MONITORING YEAR 2 REPORT

LITTLE PINE III STREAM AND WETLAND RESTORATION PROJECT

DMS Project Number 94903

RE: Response to MY2 Draft Report Comments
Little Pine Creek III Mitigation Site
DMS ID 94903
DEQ Contract Number 6844
New River Basin - #CU# 05050001 - Alleghany County, North Carolina

Figure 3.0 Integrated Current Condition Plan View Map (Key)
 Little Pine Creek III Stream & Wetland Restoration Project
 DMS Project No. 94903
 Monitoring Year 2 - 2017

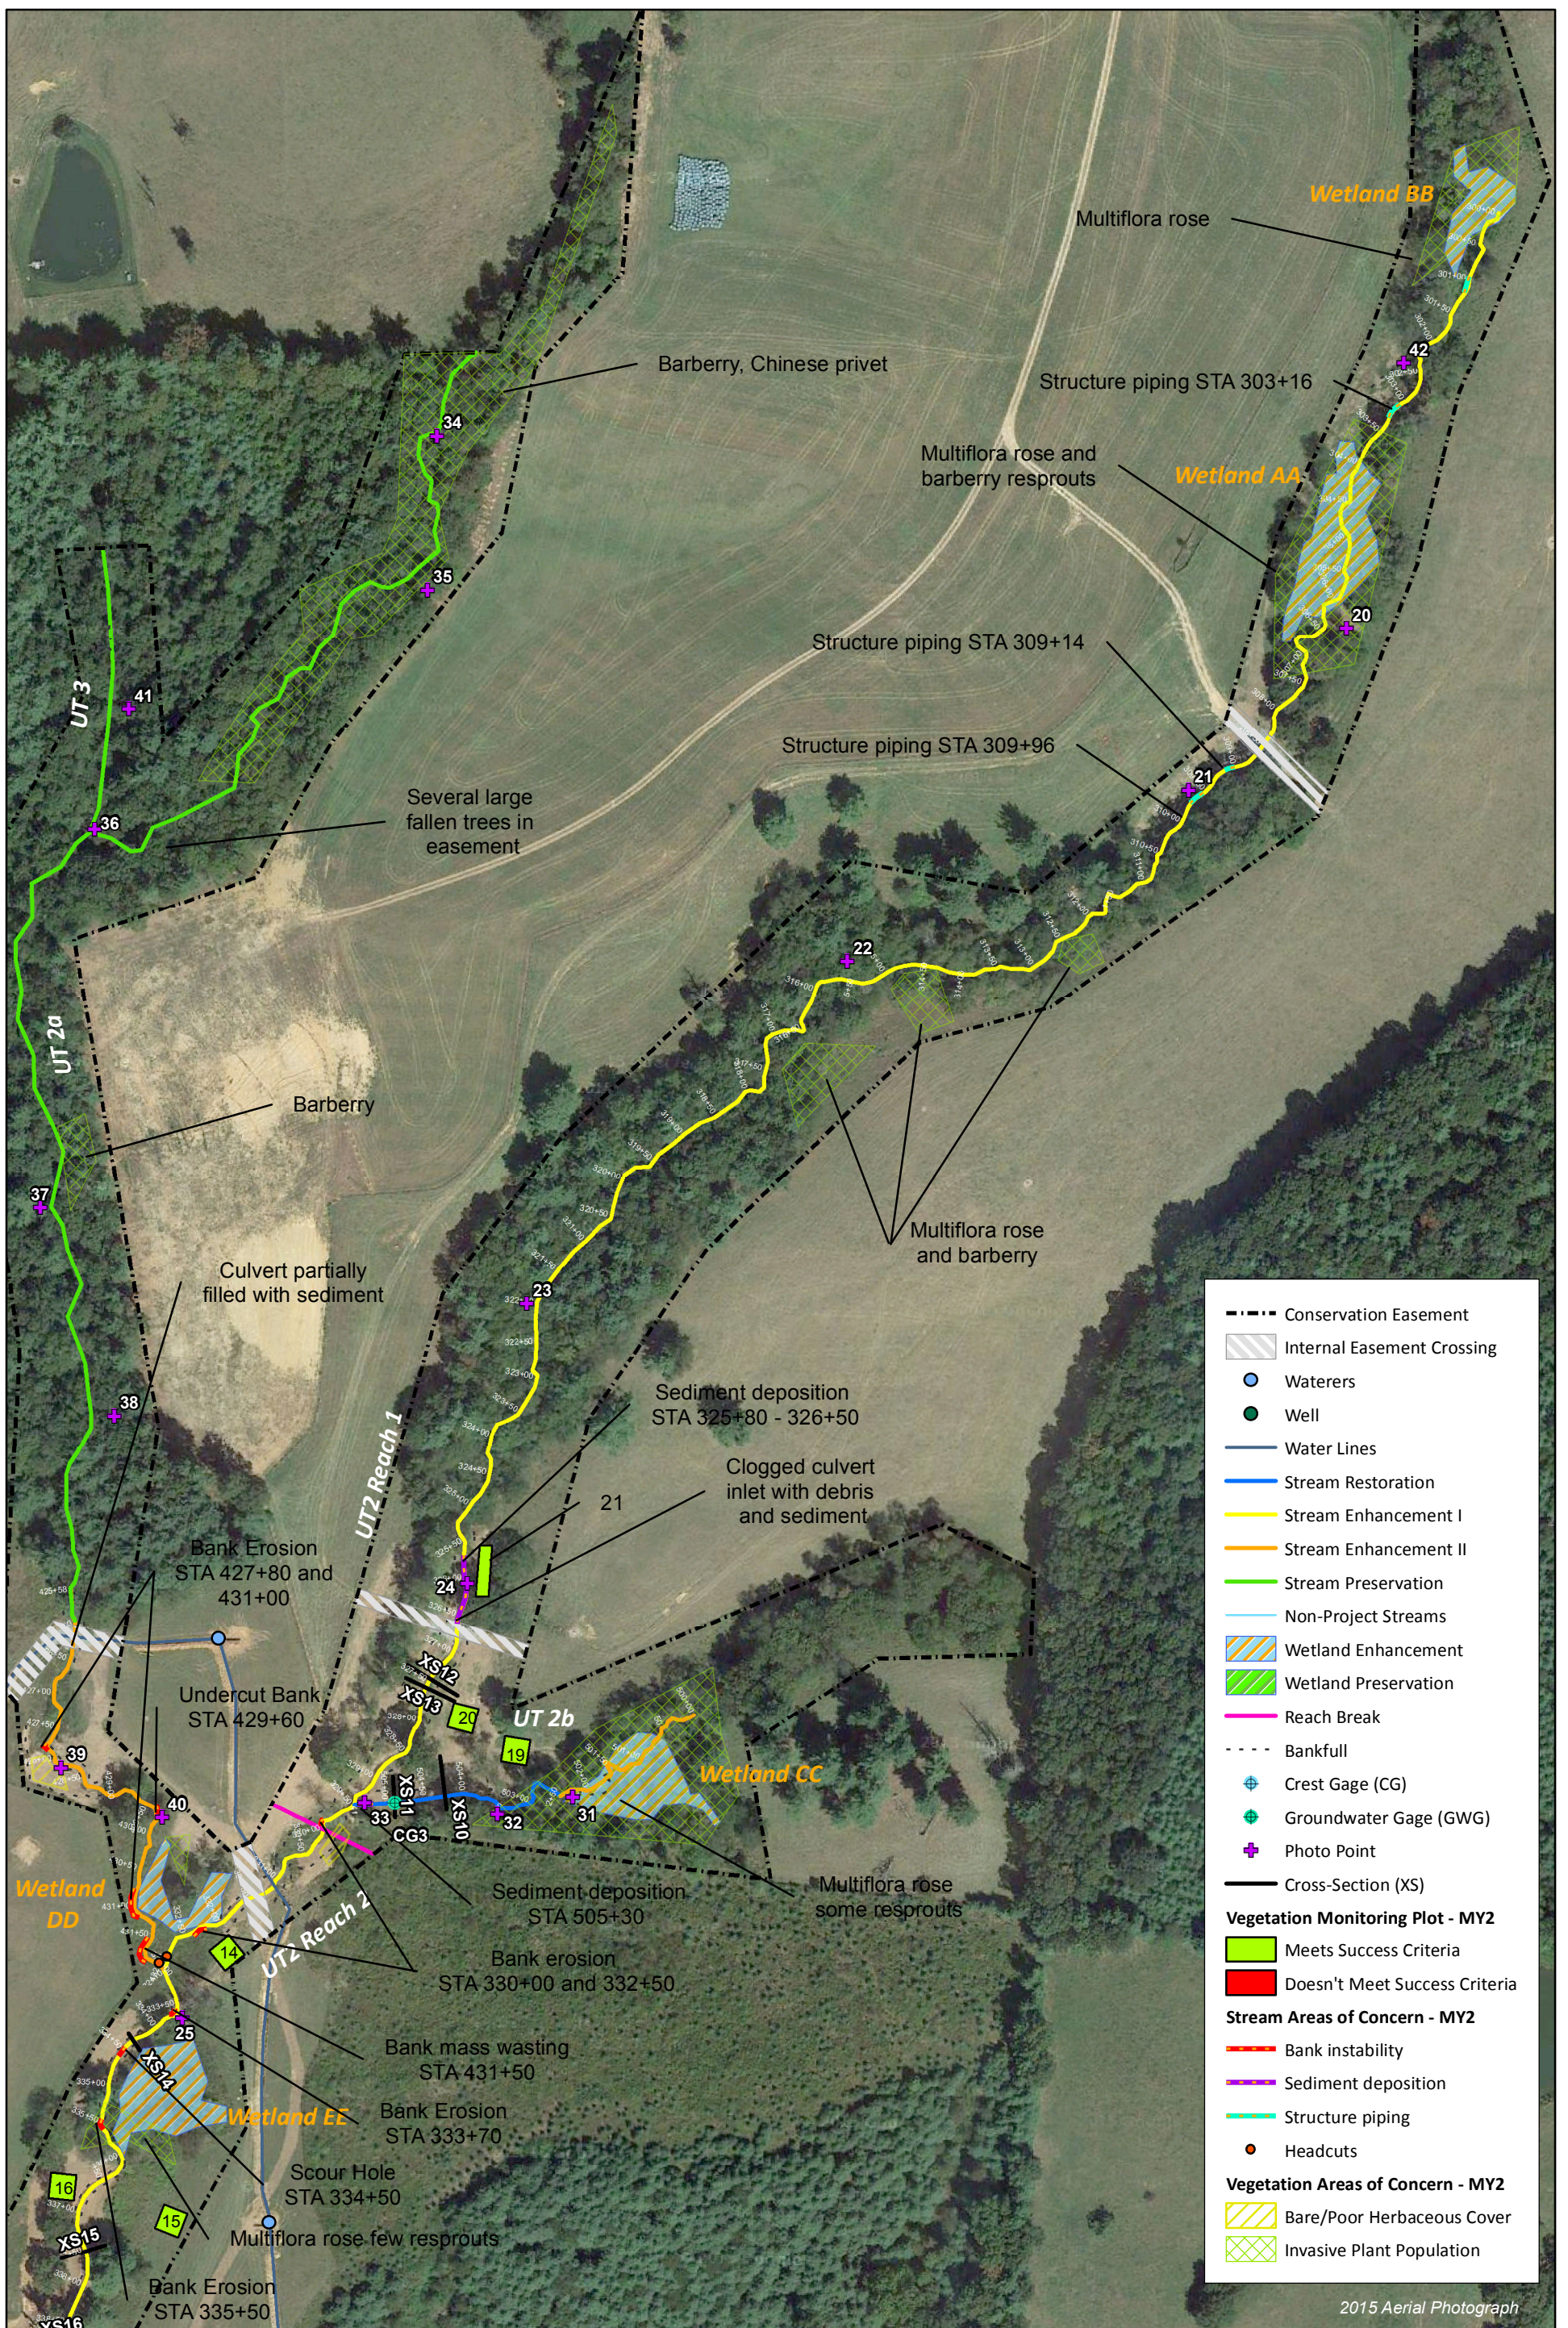
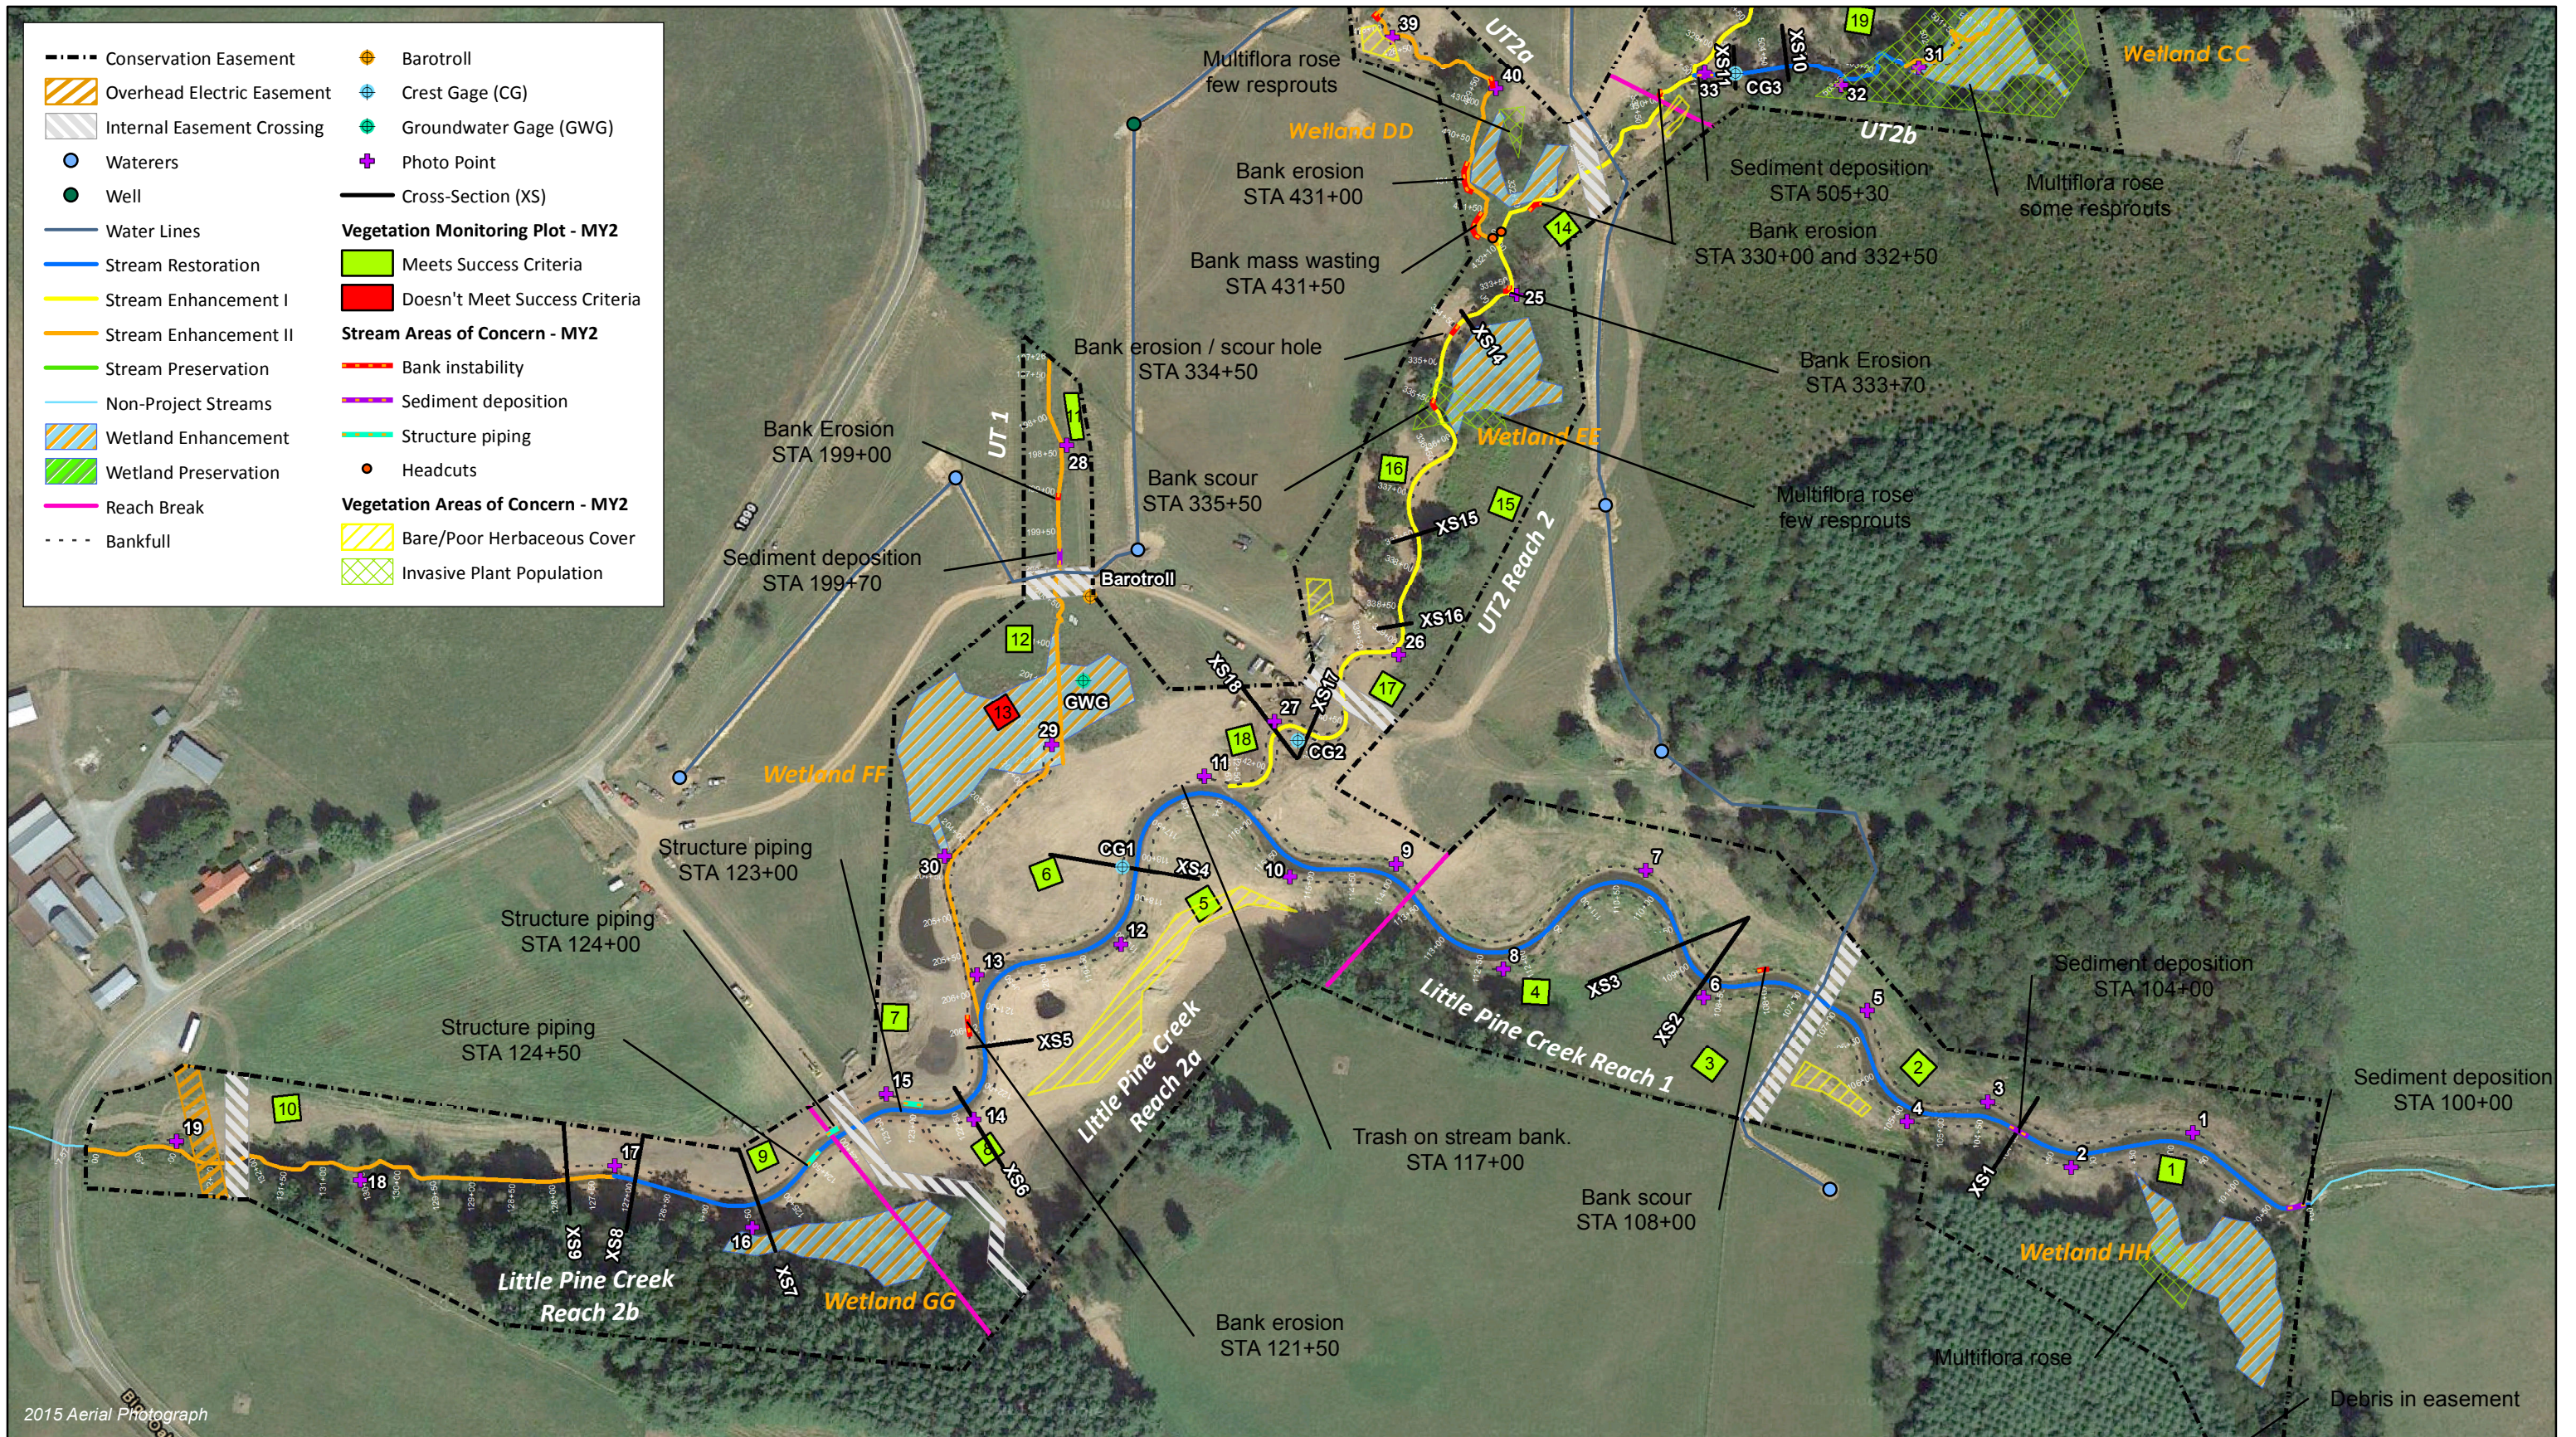
DMS comment; Stream adaptive management actions are recommended for bank instability on UT2a and the clogged culvert on UT2. Please indicate that a repair design is underway to address areas of stream instability along UT2a and UT2, including the formation of head-cuts, lateral stream migration, and excessive streambank erosion. The reach segments that will be addressed include:

DMS comment; A field visit by DMS staff on 9/27/17 showed that noticeable aggradation had developed in the UT1-lower section. This included the Enhancement II section from the culvert crossing flowing through Wetland FF to Station 202+07, and then continuing beyond the installed rock A-vane at the downgradient end of the wetland for an additional 400 feet along the segment of UT1 that was relocated to tie in with the new Little Pine Creek alignment (see designer record drawing Sheet 2.9). Please discuss the silted-in reach concern, and possible causes. If adaptive management is recommended, please discuss the feasibility/ long-term viability of any recommended management actions so DMS can make informed action decisions.

Wildlands response; Text has been added to the Executive Summary, and Sections 1.2.4 and 1.3 to indicate that a repair design is underway to address areas of stream instability along UT2a (Bank erosion near STA's 427+75, 429+75, 431+00, and 431+50, headcut near STA 432+00) and UT2 (Bank erosion near STA's 330+00-332+50 and 333+70, headcut near STA 332+90).

Wildlands response; Text has been added in Section 1.2.4 to discuss the aggradation that was observed by DMS in the UT1-lower section. Wildlands agrees that UT 1 is choked with vegetation and losing its channel form, the channel is still intact and flowing but vegetation is beginning to choke this out as it is part of a bog-like system. We believe that as woody vegetation (mainly the live stakes) grow up and shade the vegetation that the channel will remain and prosper. Our team will remove some of the herbaceous vegetation in the interim and continue to monitor this channel during our monitoring period.
